ADDENDUM ONE

**2024 Roofing and Related Work at Various Locations for:
Jennings County School Corporation**
34 W Main Street
North Vernon, Indiana 47265

Commission No.: F23097
Addendum Date: December 1, 2023

R111

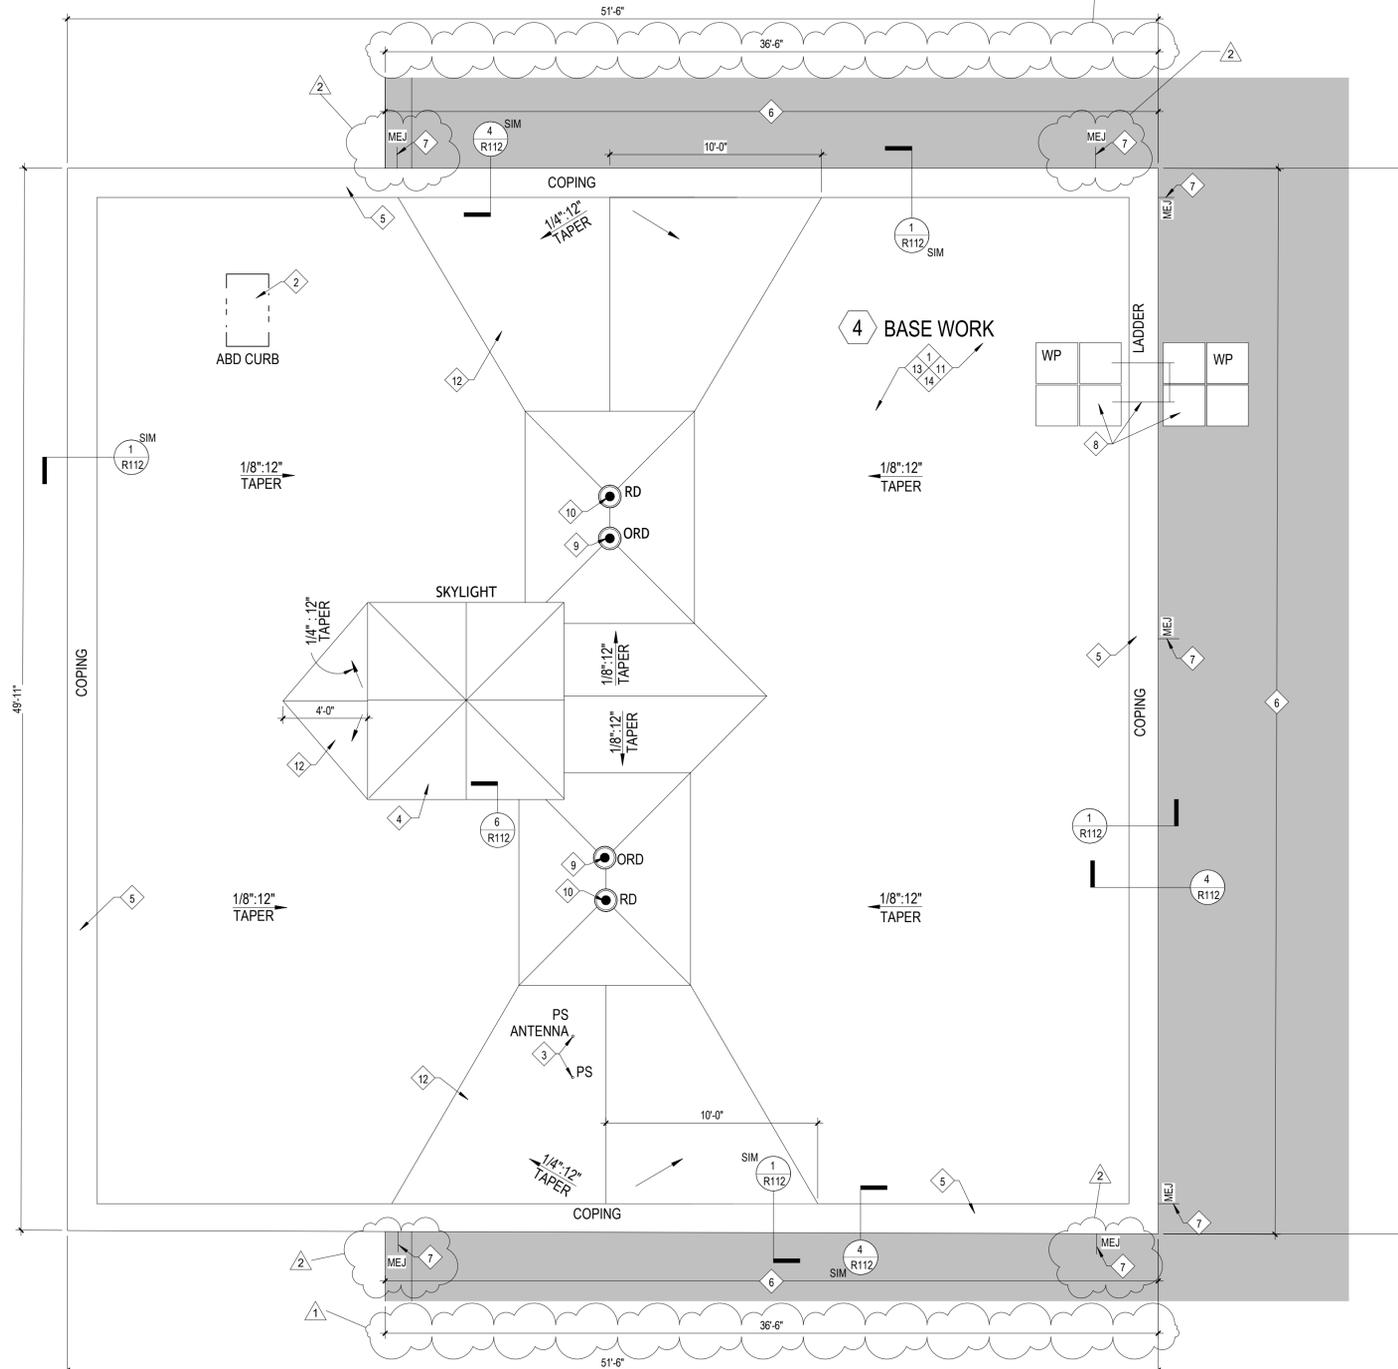
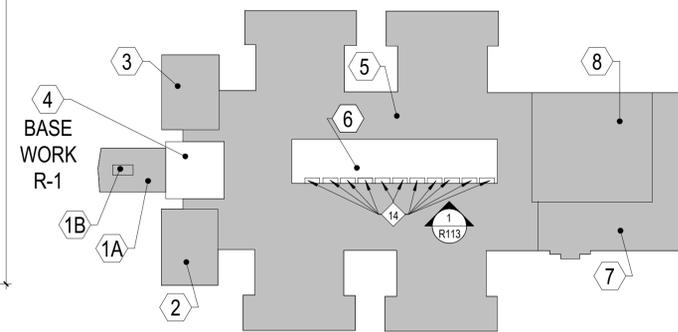
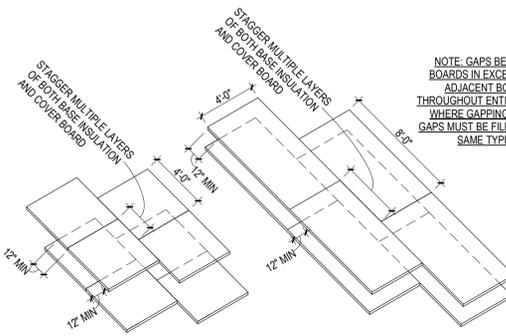
SHEET R111 - SAND CREEK ELEMENTARY PARTIAL ROOF PLAN - REMOVE AND REPLACE with Sheet R111 - Sand Creek Partial Roof Plan included with this Addendum One. This sheet shall replace the sheet included within the current construction documents.

1	Added Thru-wall Dimension	12-1-2023
2	Moved Existing MEJ to Correct Position and Added 2 Missing existing MEJ	12-1-2023
